SERVICE BULLETIN **Buell**[®]

B-033A

December 4, 2000

SAFETY RECALL CODE 0820 - NEW SHOCK ABSORBER

Figure 2. New Shock Absorber Assembly

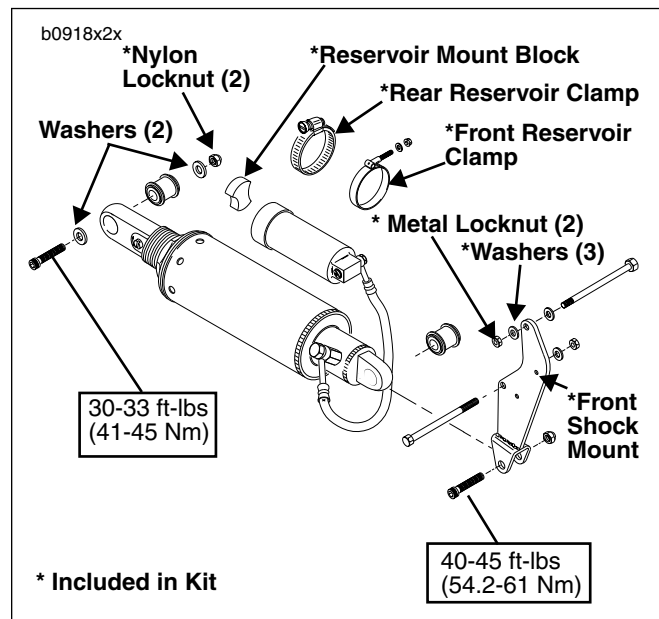
The new front shock mount **MUST** be used with the new shock absorber. The new shock is 1.77 in. (45 mm) shorter than the previous shocks and requires the new front mount to align and install properly.

1. See Figure 2. Install new front shock mount to crankcase with two **new** front shock mount bolts, washers and metal locknuts. Tighten bolts to 30-33 ft-lbs (41-45 Nm). NOTE: Top bolt goes in from the left side, bottom bolt goes in from right side. The bottom bolt does not use washer under the bolt head.

4. See Figure 2. Position **new** shock absorber from kit in mounting position.
5. Loosely install bolt, washers and **new** locknut through rear shock eye and swing arm.

Figure 3. Reservoir Clamps (X1 Model Shown)

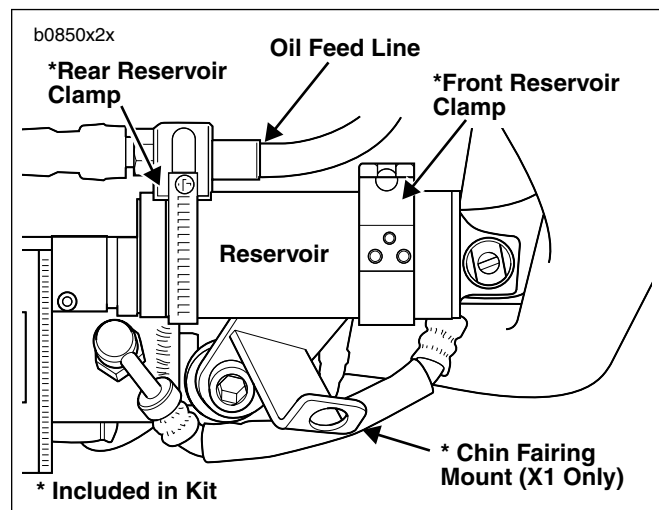
9. See Figure 3. Loosely install **new** rear clamp around reservoir and oil feed line.
10. **All Models:** Install **new** reservoir mount block between oil pump fitting and remote reservoir.
